CHARLTON
RIVERSIDE
P H A S E O N E

ENVIRONMENTAL STATEMENT ADDENDUM
VOLUME IIIA: TECHNICAL APPENDICES

**Leopard Gurnsey Anchor
Propco Ltd**
Anchor and Hope Lane Sites
Charlton Riverside
Transport Assessment
Addendum

Response to Consultee Comments

DRAWING NUMBER 30821/AC/216

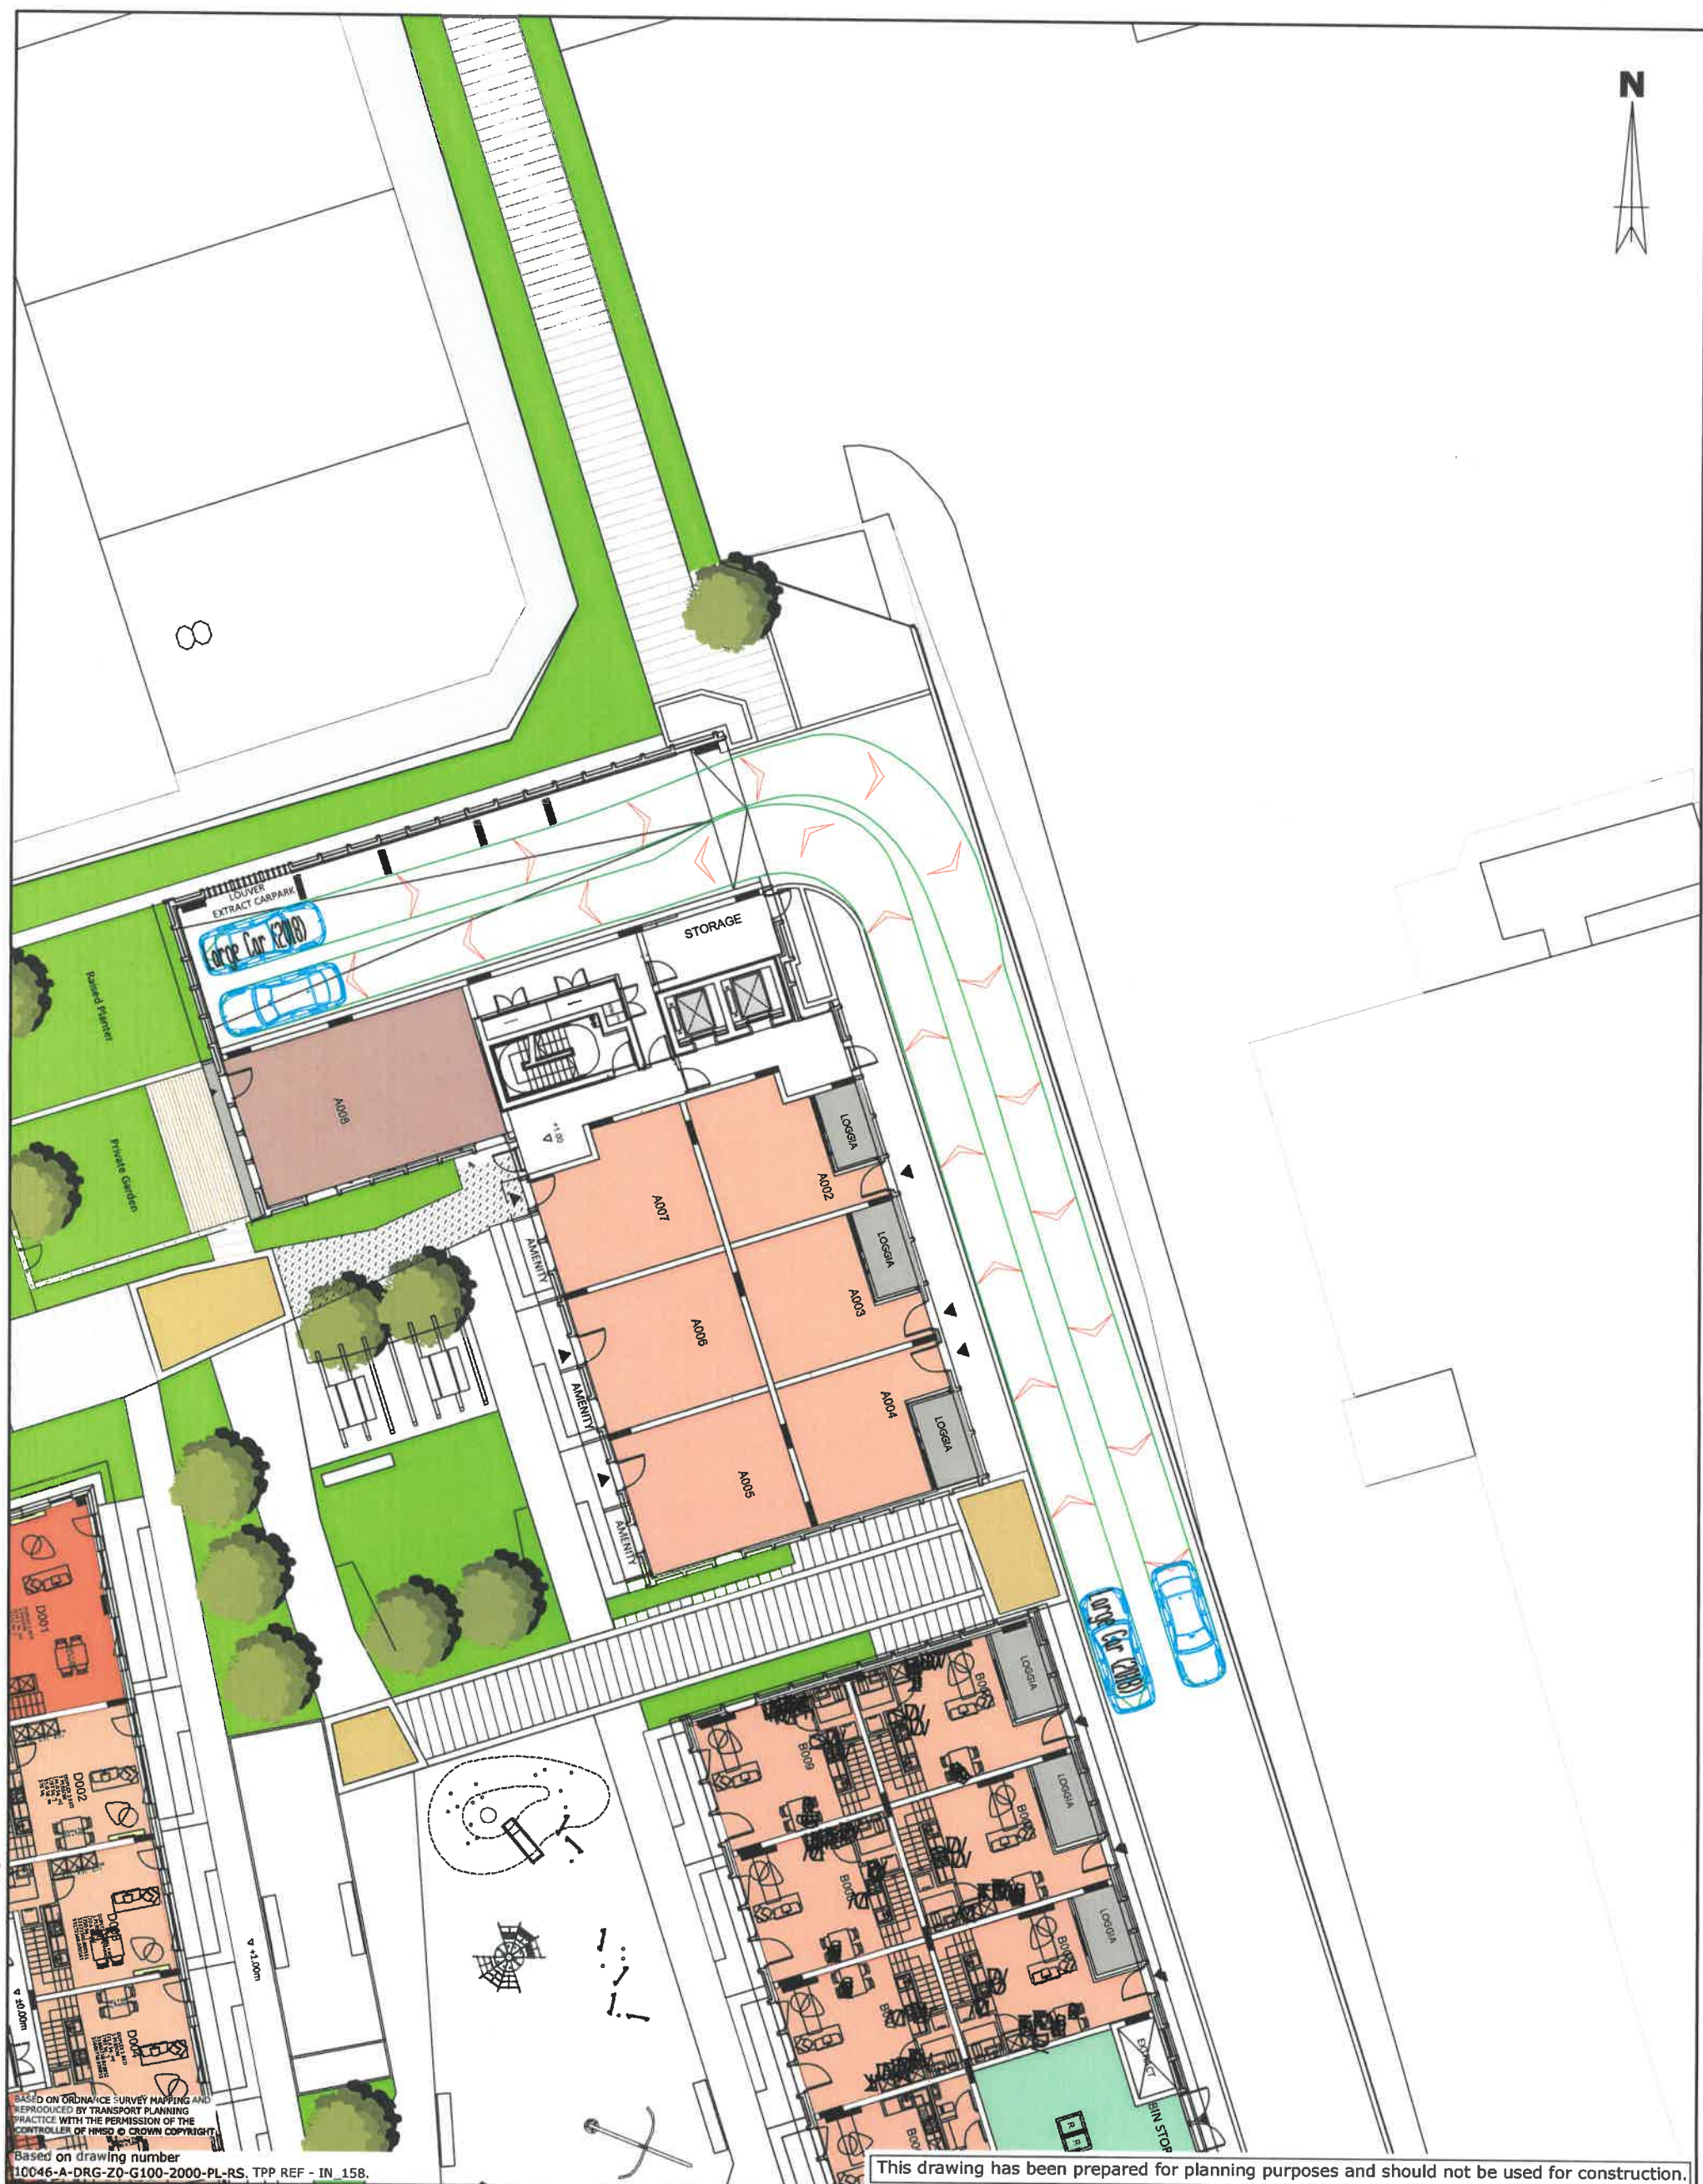
3.2.2 The extent of the highways works on the public highway remains unchanged and this is shown in Drawing 30821/AC/216_C included in Appendix B in the context of the amended scheme.
